Environmental Minor Project Refinement Form

Project Name: West of Devers Upgrade Project Request Prepared By: Sylvia Granados

Date Approval Required: 5/11/2018 Variance Request No.: 11

Southern California Edison
West of Devers Upgrade Project
MPR #11-
Nevada St - Subtransmission Alternative
Work Area Request

FIGURE 2-2

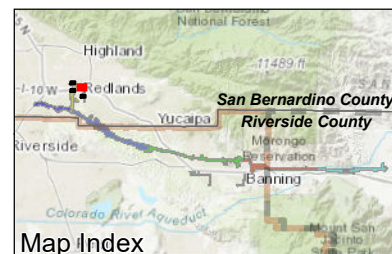
Five subtransmission structures proposed for construction on the east side of Nevada Street, between Almond Avenue and Lugonia Avenue, have been redesigned for installation along the west side of Nevada Street, south of Almond Avenue and north of Lugonia Avenue, as shown on Figure 2-2.

The temporary impacts to developed/disturbed land associated with the redesign are 0.84 acres.
